Subject: Updated Heavy-Duty Solo Clutch In-Vehicle Resetting Procedure

Document Number: CLIB0026

Date: February 11, 2013

Updated: May 28, 2013

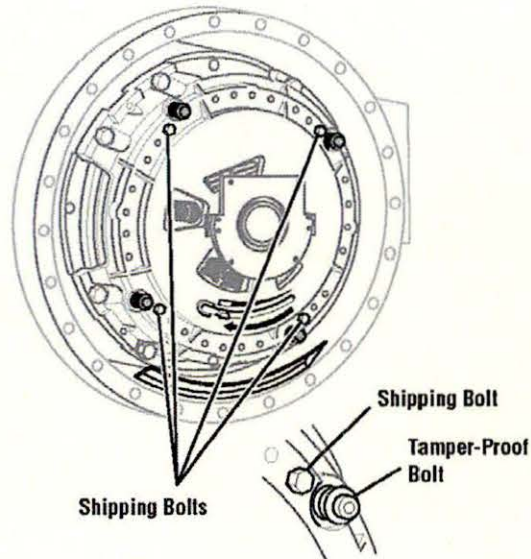
- 7** With the free pedal removed push the clutch pedal down at least 5 times. Make sure the clutch release bearing contacts the clutch brake.

Note: For mechanical linkage, while engaging and releasing the clutch, the cab free pedal will increase. This indicates the Solo is adjusting to the environment.

Note: For hydraulic linkage, be sure to stroke the clutch pedal all the way to the floor, ensuring that the release bearing is being stroked far enough for the clutch to make an adjustment. With a hydraulic release system there will be no change in free pedal when the Solo clutch makes an adjustment.

Verify Clutch Brake Squeeze

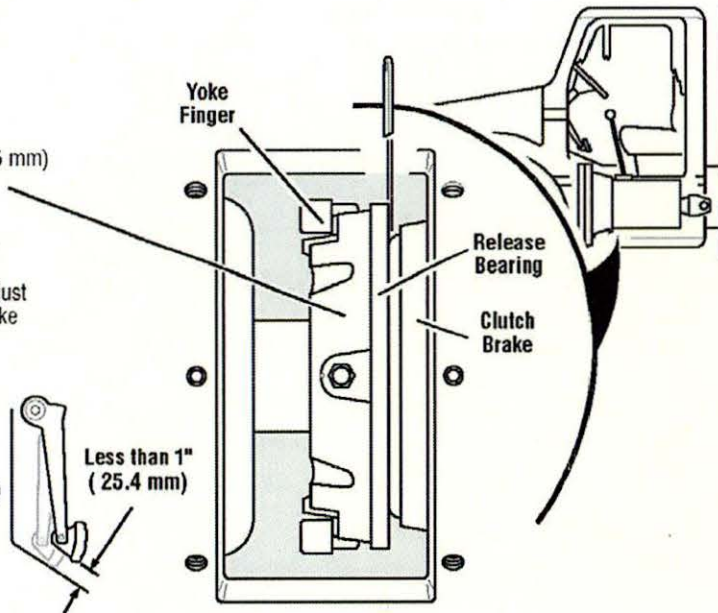
- 1 Have an assistant insert 0.010" (0.25 mm) feeler gauge between the release bearing and the clutch brake.

Press the pedal down to the floor to clamp the gauge:

- If the gauge does not clamp, readjust the truck linkage and move the yoke finger closer to the bearing.

- 2 Slowly let up on the pedal and measure the pedal position at the moment the gauge can be removed:

- If pedal is more than 1" (25.4 mm) from the floor, readjust the truck linkage to move the yoke fingers further from the release bearing. Repeat **Step 1**.
